Kiama Aged Care Centre of Excellence

## Section 79C Assessment

Application number	DA10.2015.198.1
Site Address	14A Bonaira Street Kiama Lot 1 DP 596755
Proposal	Demolition of existing structures on site with the exception of heritage listed Barroul House.  Construction of: <ul style="list-style-type: none"> <li>• One 134-bed residential aged care facility (RACF).</li> <li>• Three independent living unit (ILU) blocks providing a total of 51 units, including one common basement parking level.</li> <li>• One assisted living unit (ALU) block providing a total of 16 units.</li> <li>• One community support services, activities and administration centre.</li> <li>• Internal roads, pedestrian walkways, utility services and stormwater drainage infrastructure.</li> <li>• Total of 139 car parking spaces at grade and on basement levels.</li> </ul>
Date of lodgement	August 2015
Owner	Kiama Municipal Council
Applicant	Kiama Municipal Council
Submissions	6 objecting, 1 supporting.

Figure 28: Shadow diagrams of 17 and 18 bed pods of RACF.

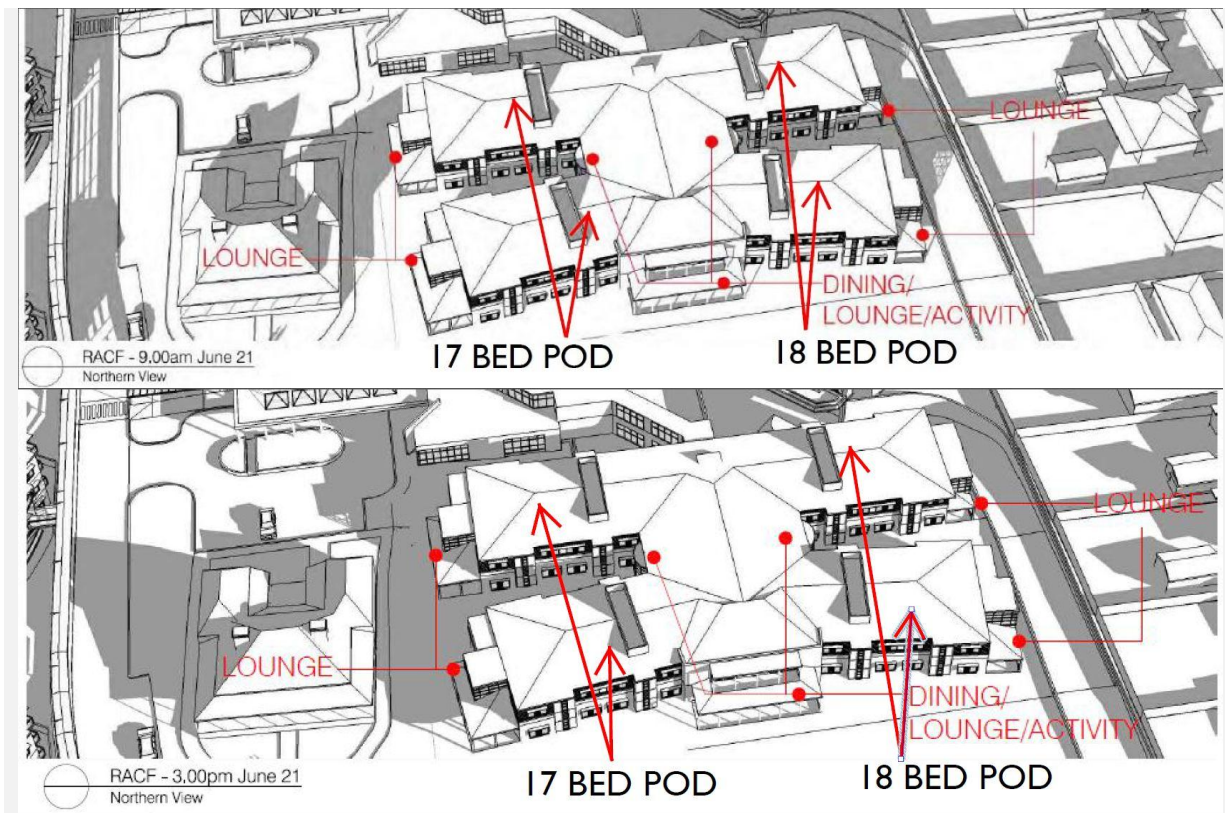
- 18 and 17 Bed Pod North West Portion of the Site (see Figure 28).
  - 18 and 17 Bed Pod address Bonaria Road.
  - Terraces and Lounge areas receive sunlight between 9.00am and 2pm. These are north facing and not overshadowed by any built form.
  - Lounge and activity areas will receive sun between 9.00am and 2pm.
  - Bedrooms that are facing south and north facing rooms located behind the northern wing will not receive direct sunlight during winter.
  - Northern facing bedrooms fronting Bonaria Road will receive in excess of three hours sun during winter.
  - Western facing bedrooms will receive sunlight between 12pm and 3pm (see Figure 29).
  - Future development on the subdivided north western portion of the site will have to consider overshadowing of western wing of RACF.

Figure 29: Shadow diagrams of 18 and 16 bed pods of RACF.

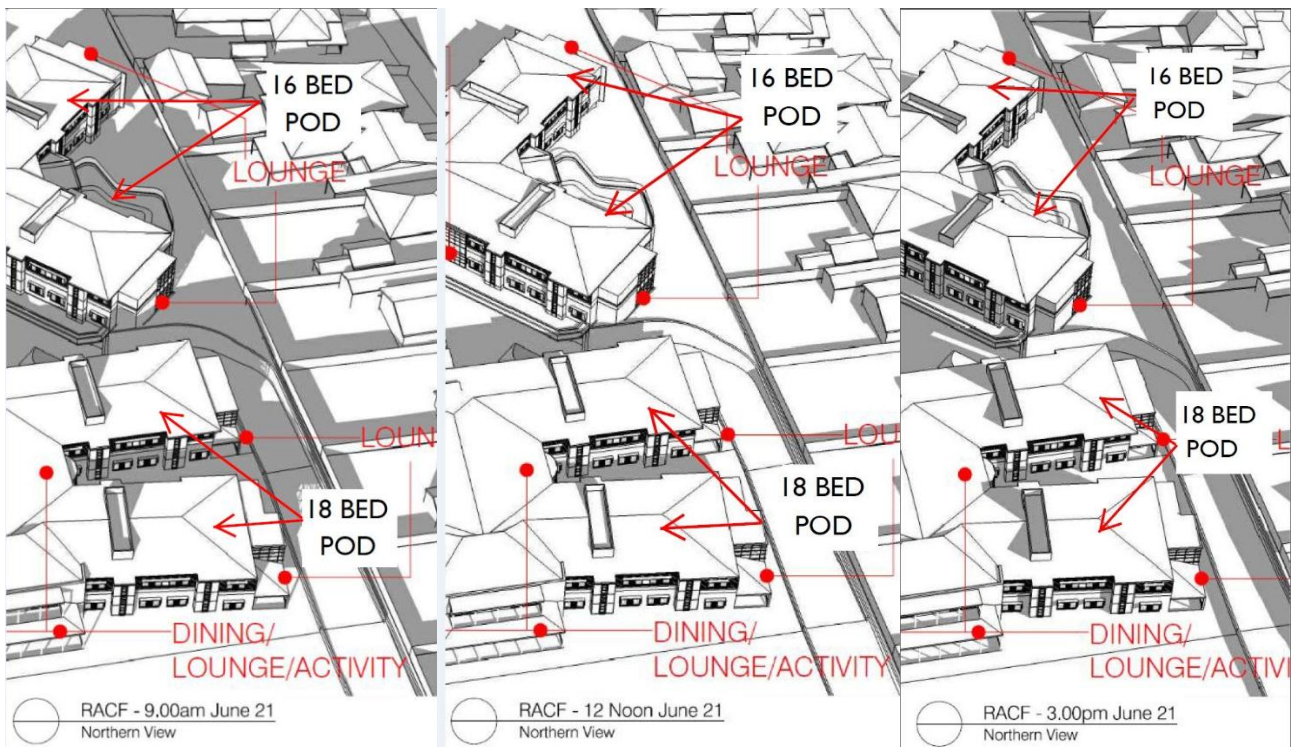
17 pod and 18 Pod of the Residential Aged Care Facility its rooms, its common spaces and its communal open space areas receive the most amount of access to sunlight.

Over 50% of all bedrooms do not receive direct access to sunlight.

The communal open spaces are large in size and would accommodate the residents of these pods during the day to enable these residents to have access to sunlight in winter months.

Figure 30: Shadow diagrams of ALU/ Community Activities Centre.

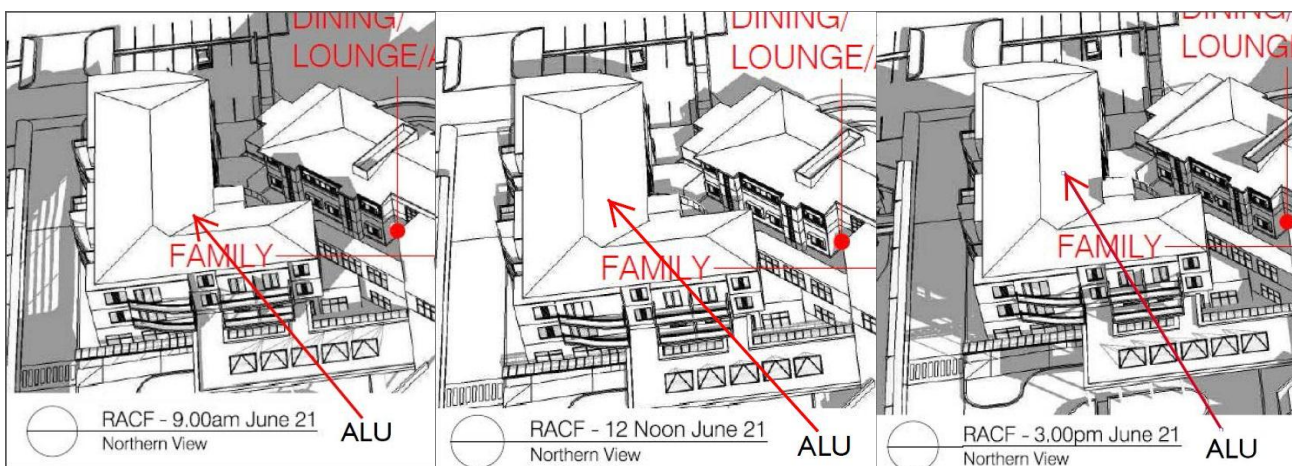
- Community Activities Centre and Assisted Living Units(see Figure 30):
  - Private Balconies of upper two levels of the assisted living units (along northern boundary) receive direct sunlight between 9 and 1pm.
  - Lounge and Communal open space of this area does not receive direct solar access till sunlight till 1pm.

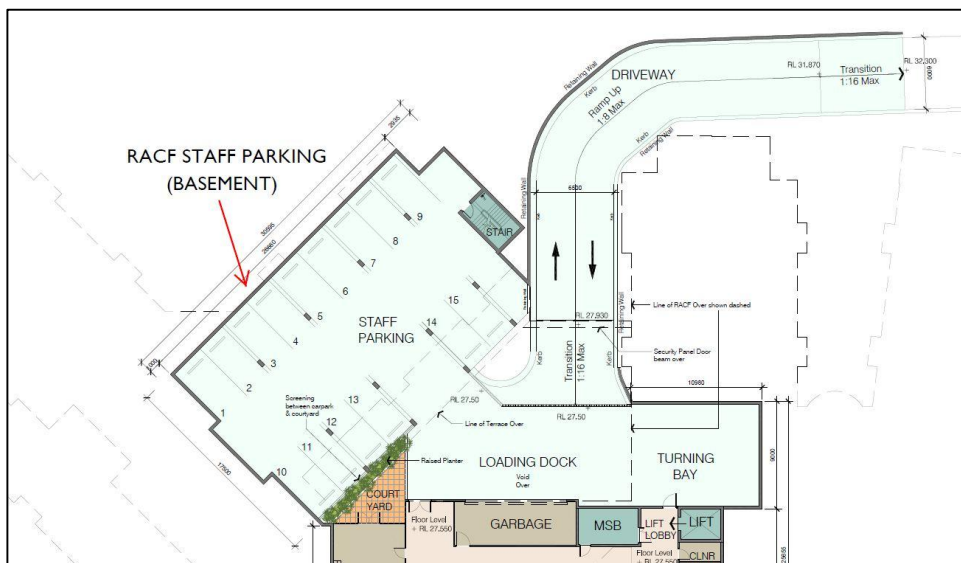
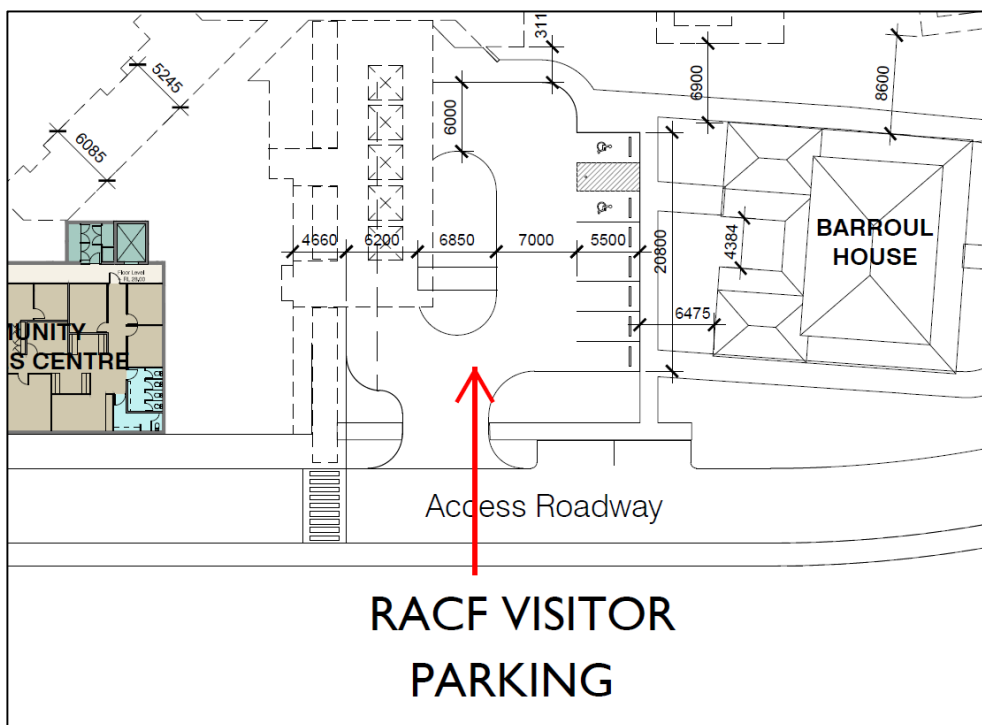
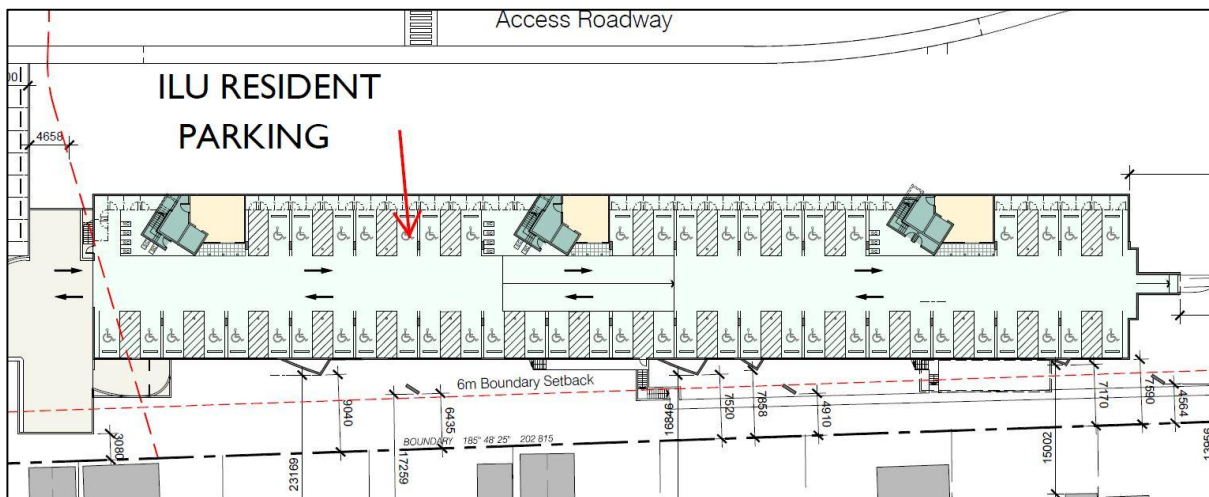
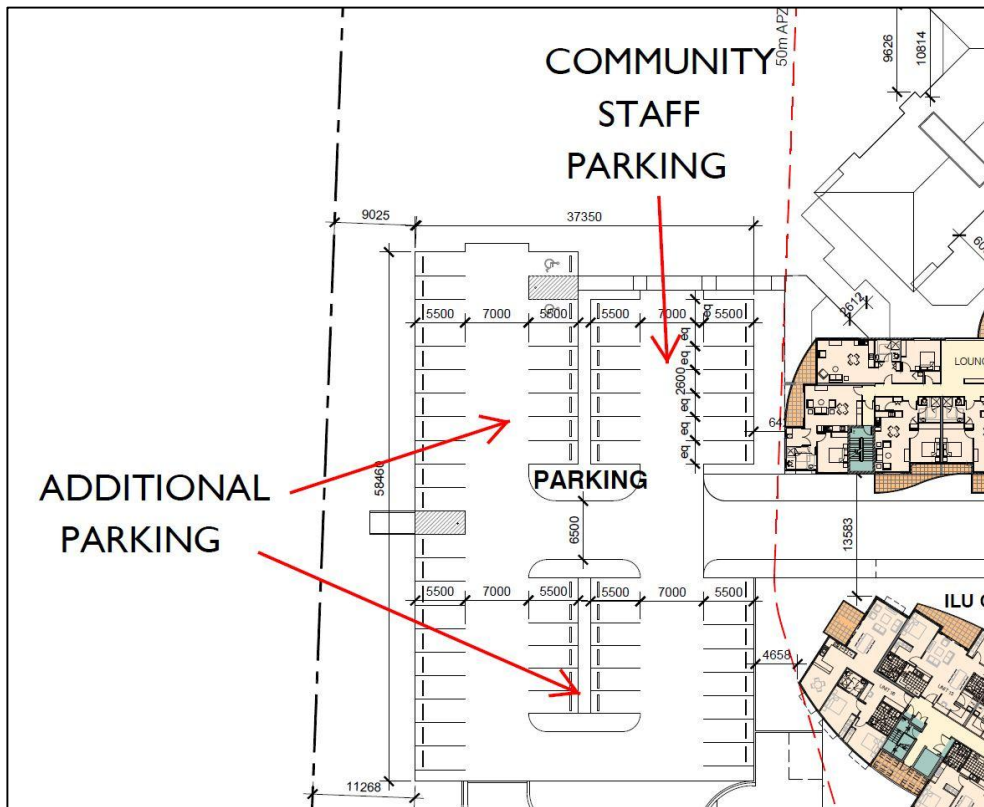
RACF Staff Parking – basement (Figure 34).	15
RACF Visitor Parking (Figure 35)	10
ILU Resident Parking (Figure 36)	51
Community Staff Parking (Figure 37)	14
Additional Parking (Figure 37)	49

- The proposed number of Car parking spaces is compliant.

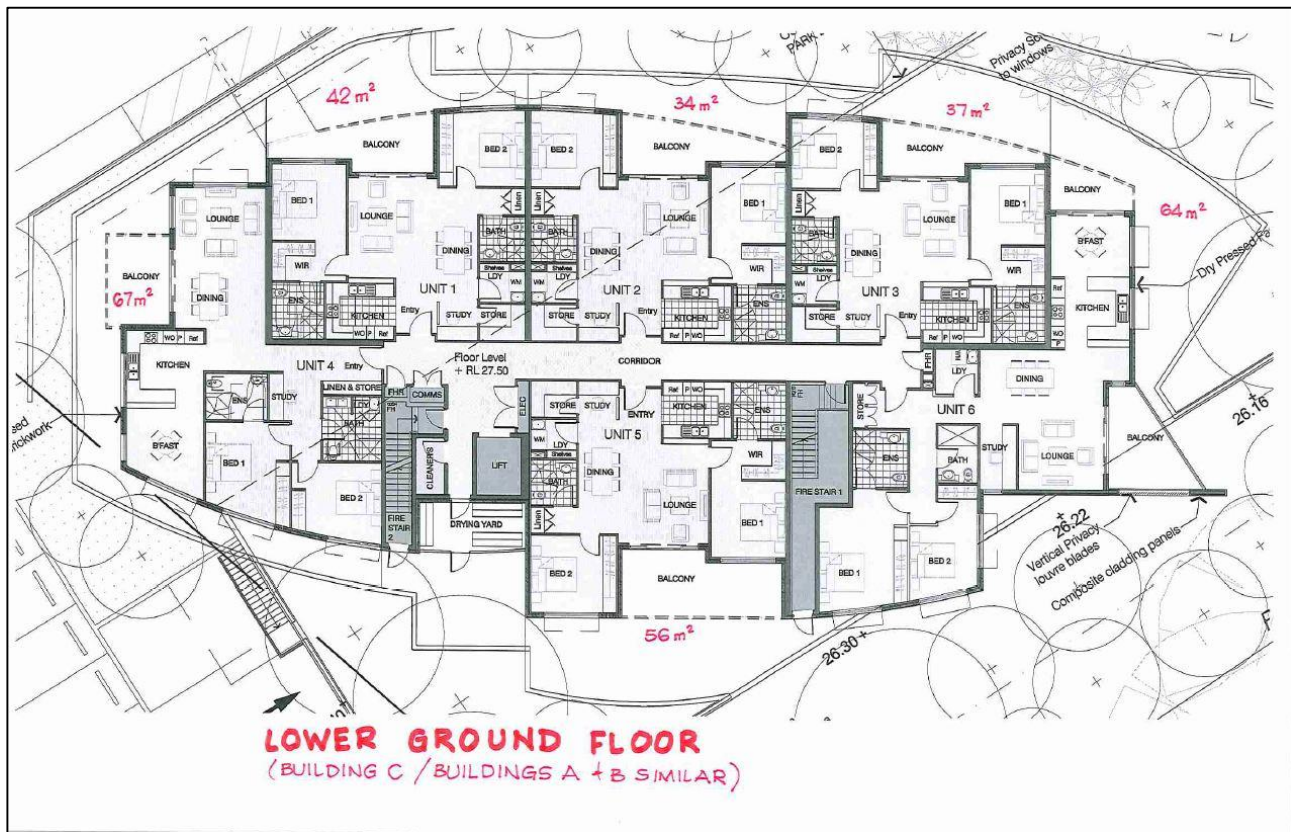
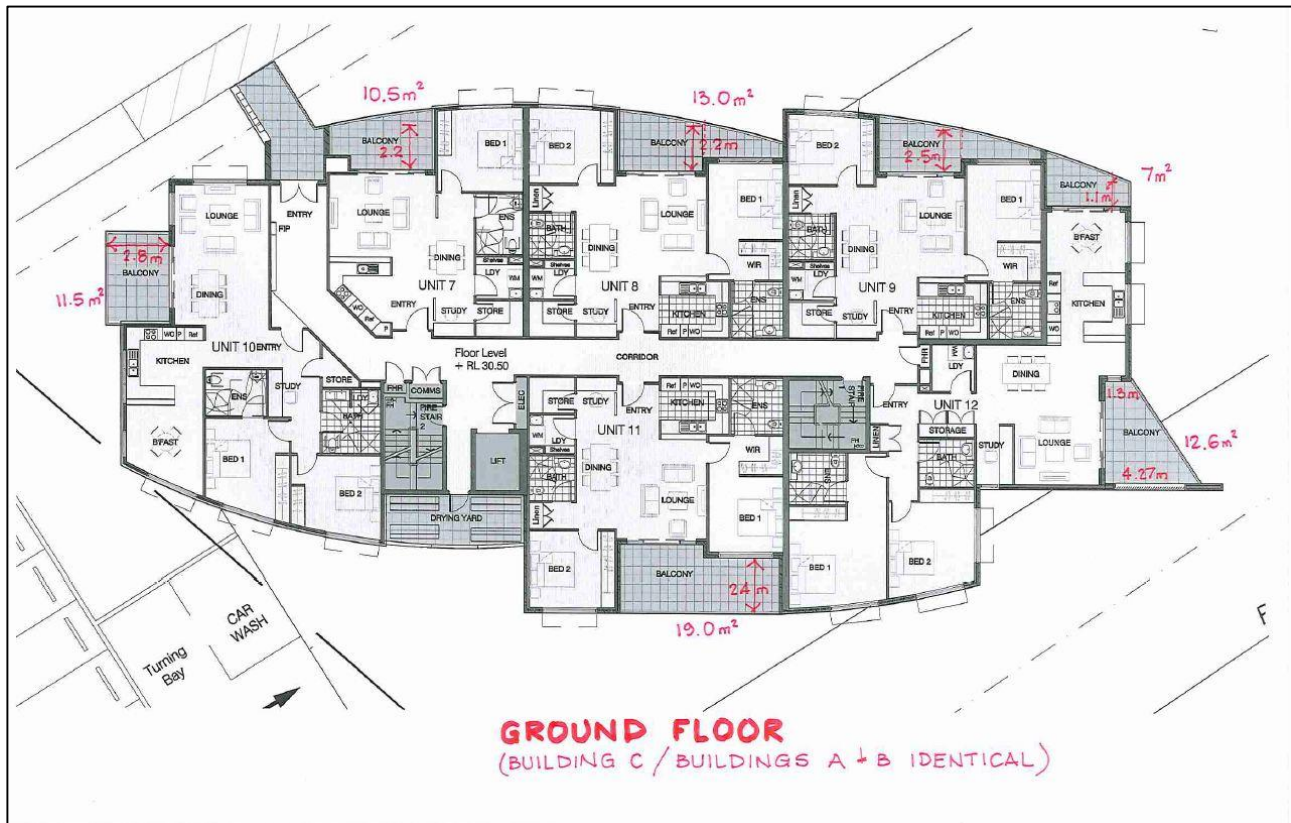
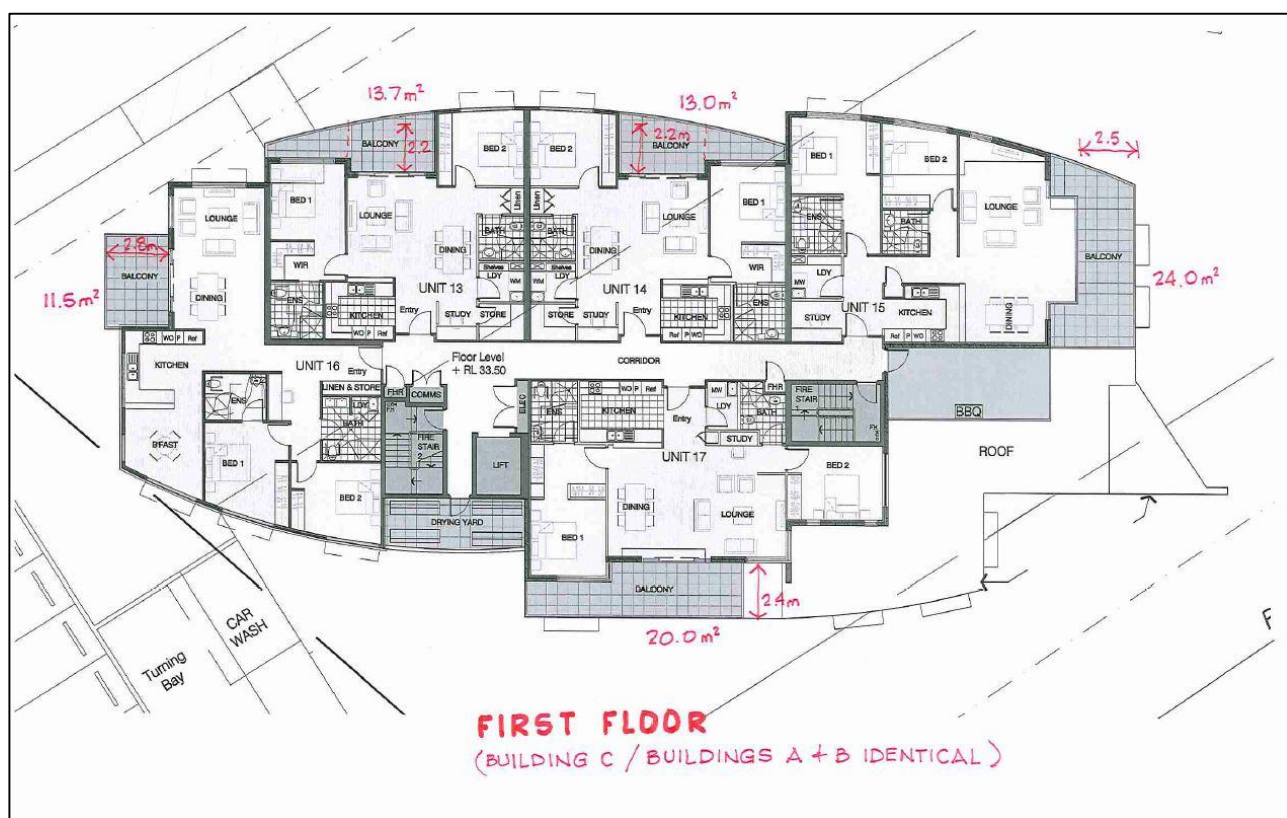
- Floorplans illustrating private open space have been reviewed and are included below (see Figures 38-40).

- Provision of private open space is compliant with this clause for ground level dwellings and for dwellings above.

Figure 41: View of development from Gwinganna Avenue (boffa robertson group).

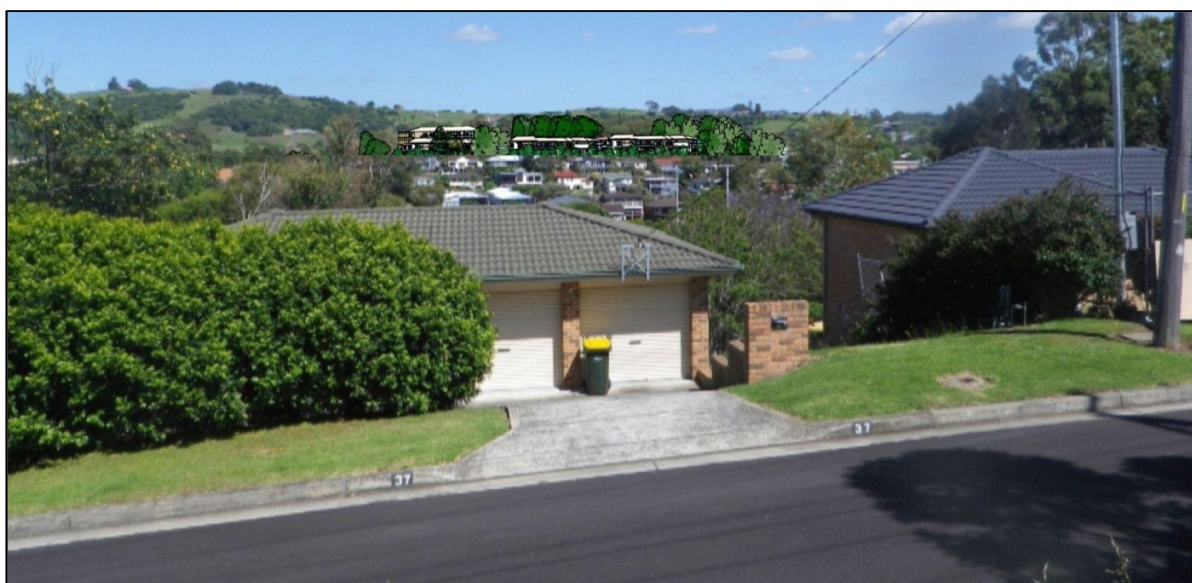
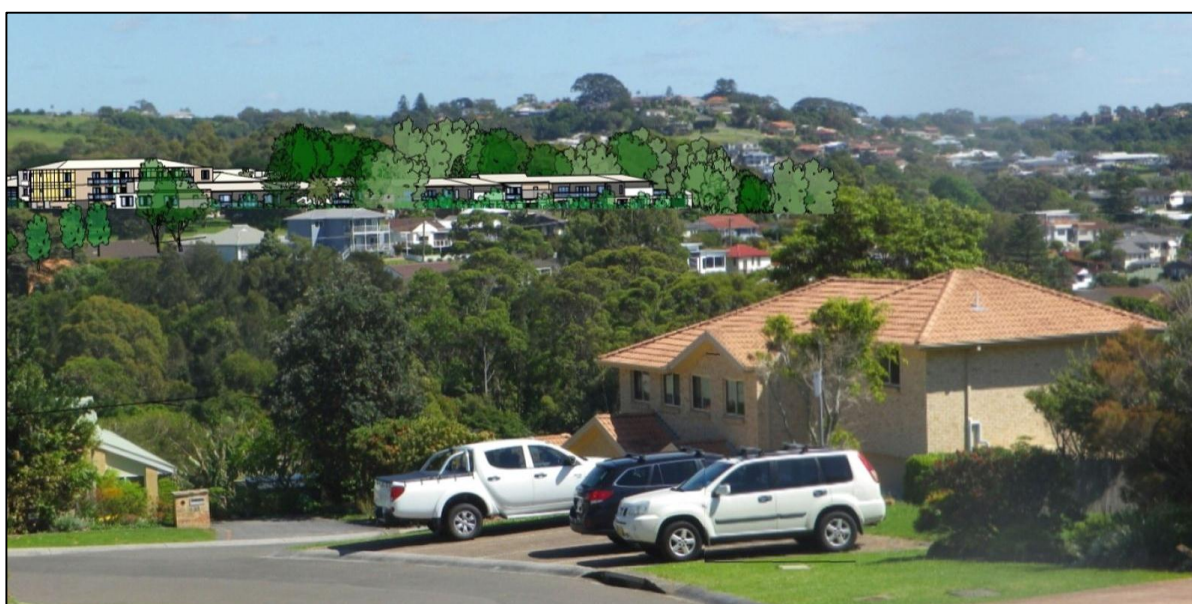
- Figures 41 and 42 above indicate that the proposal will be visible from Gwinganna Avenue and Whitten Place.

- The view is impacted moderately, however the ridgeline will not be blocked as a result of the development.
- **Balconies of ILUs provide overlooking into Holden Avenue properties / Overshadowing of ILUs**
